**Statement of Environmental Effects [SEE]
Unit 1, 48a Queenscliff Road, Queenscliff
for Margaret and Stephen Stanton**

This S4.55(2) Application (formerly S96.2) seeks Council approval to modify DA Consent DA2018/0823 issued by Council on 02 October 2018. This consent was based on architectural drawings prepared by Day Bukh Architects.

MOD2019/0407

drawing:
**Unit 1 Proposed Plan &
Site Location Plan**

S4.55(2)	200.01
scale: 1 : 100 @ A1	Date: 07.08.2019

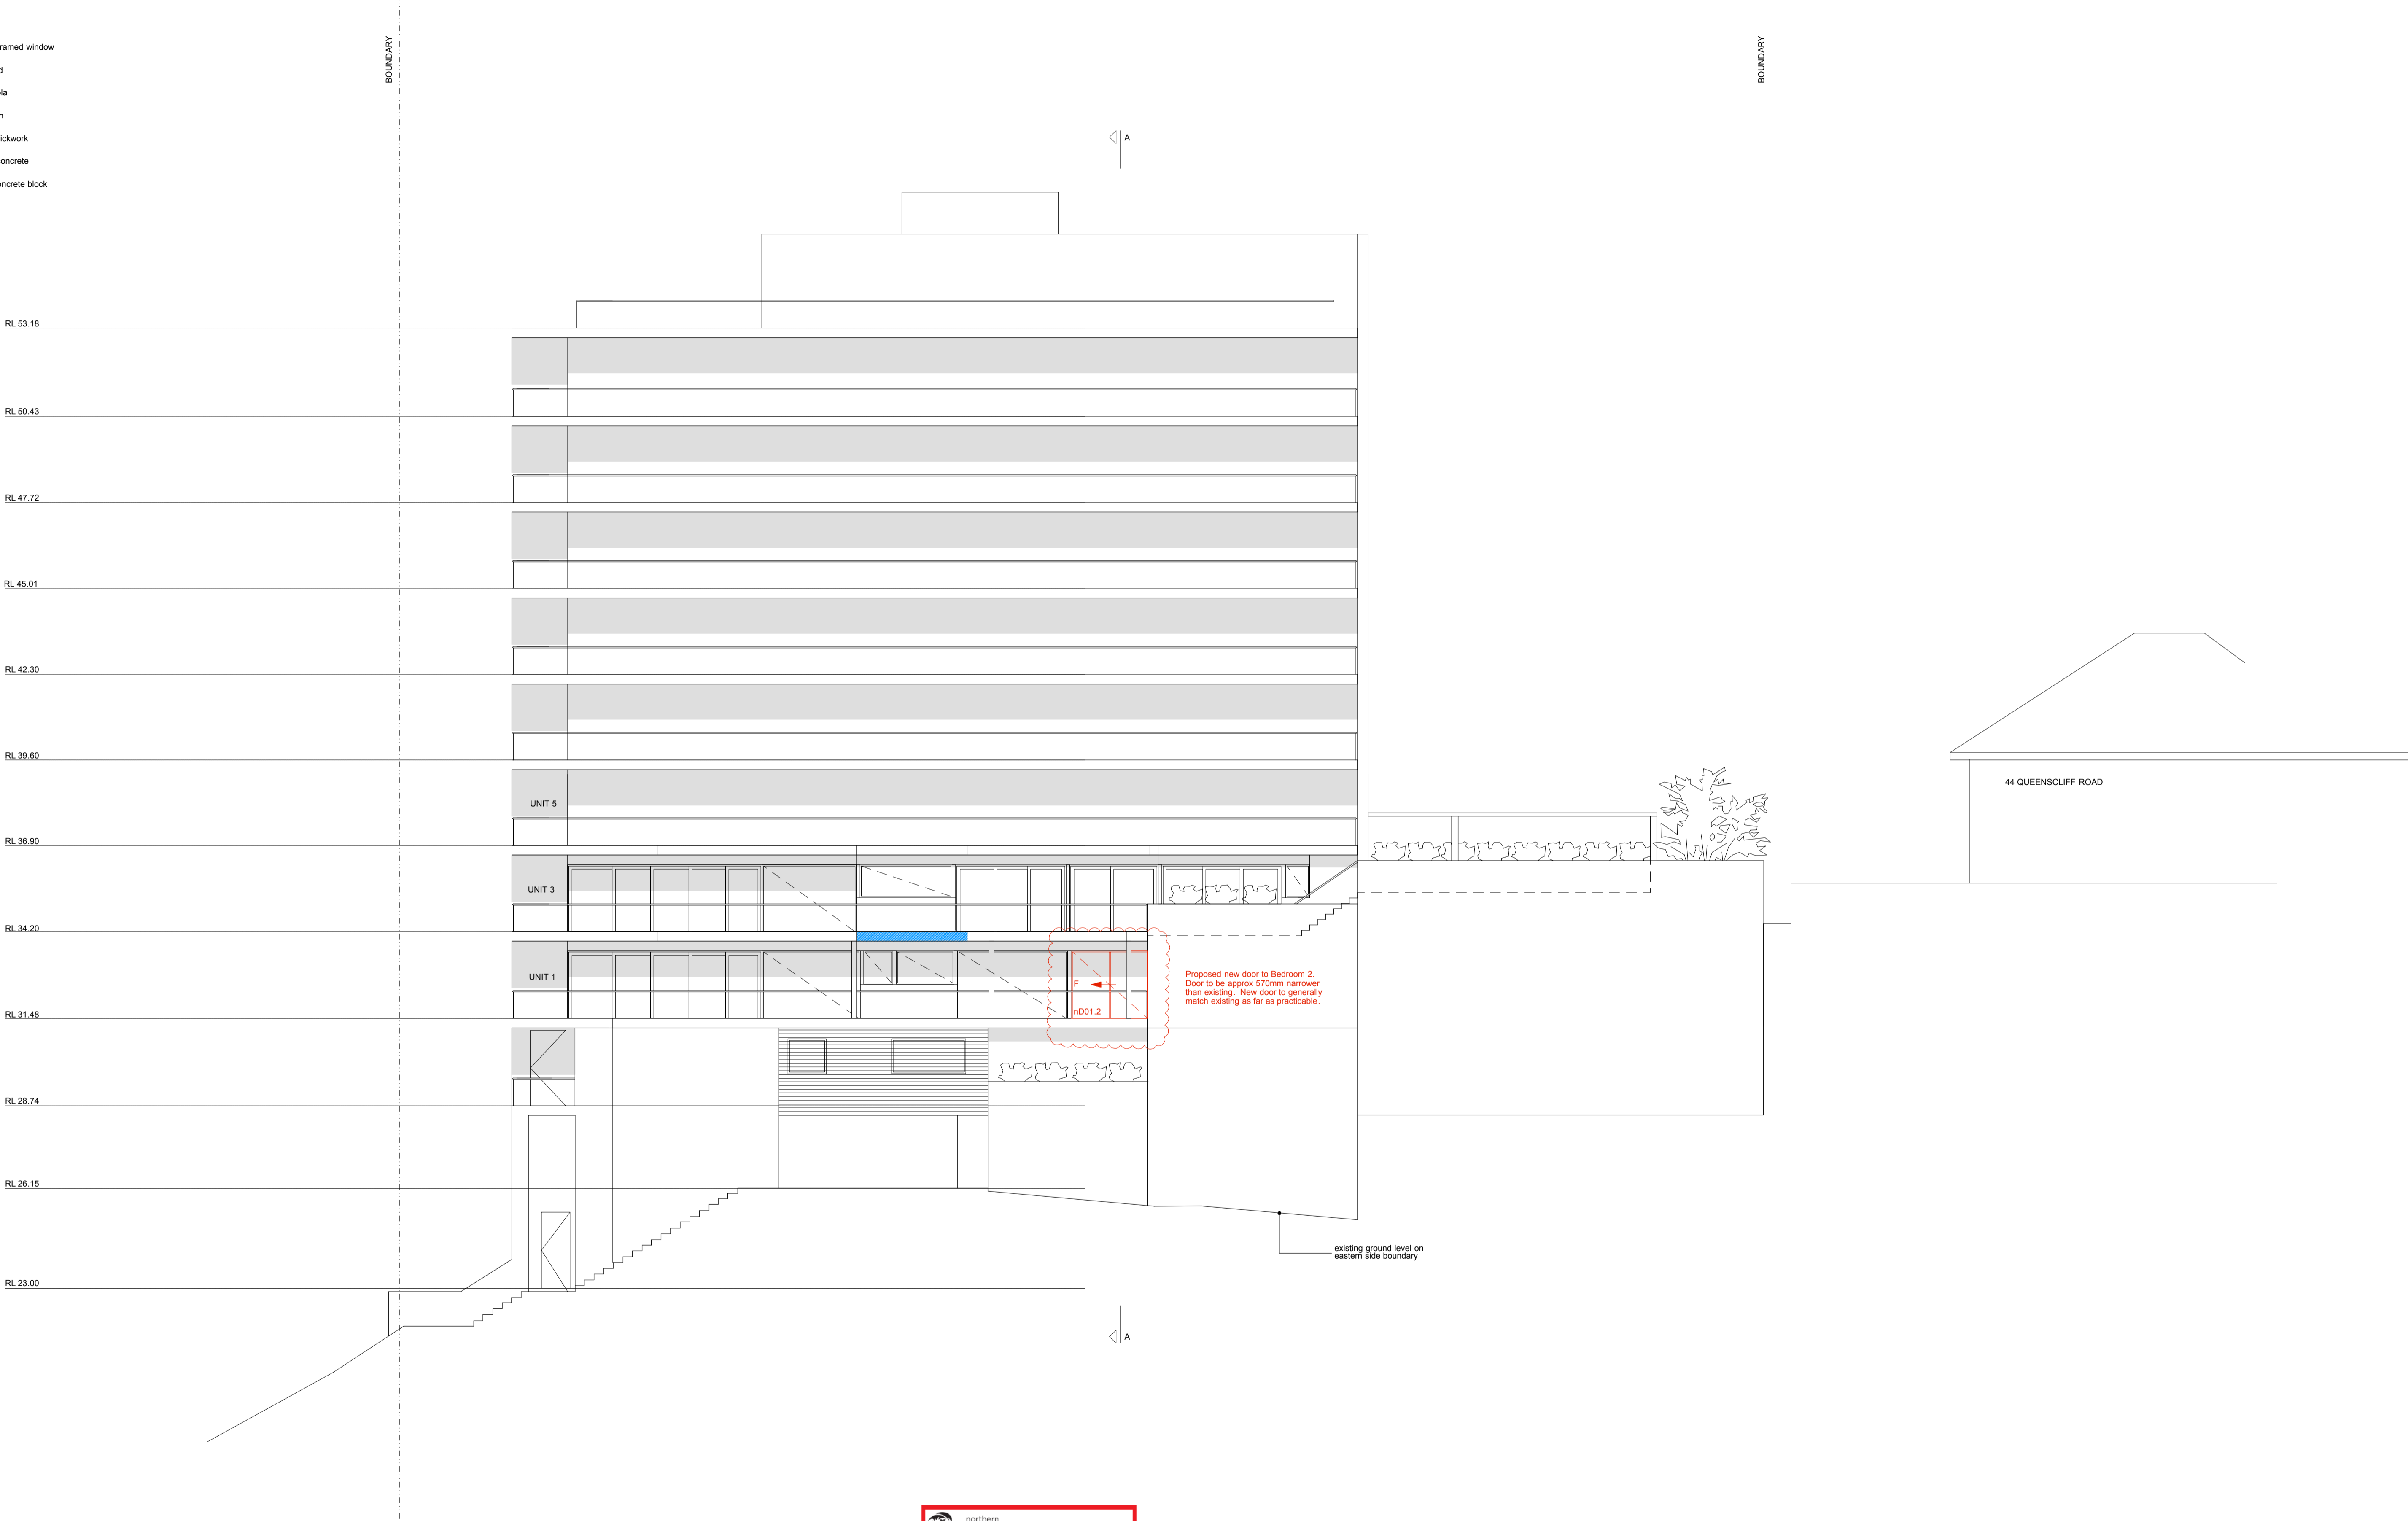
1. *Internal modifications:* relocation of the shower, ensuite, WIR, laundry as well as modifications to the general bedroom layout. We also propose to install a structural steel support beam in lieu of a previously approved blade wall.

- 2a. We propose to change the alignment of the external glazed door providing access from Bedroom 1 to the external Balcony (shown on the attached drawing S4.55-01 as nD01.1). As a result, approx 2.9m² will be added as internal space to the apartment. Accordingly, 2.9m² will be lost from the Balcony. It is the author's view that this minor additional floor space will not be perceived from any external viewing point.

- 2b. as a result of the proposed change to door nD01.1, we further propose to alter door nD01.2. We propose that nD01.2 visually match the existing door it replaces, albeit being approx 570mm narrower.
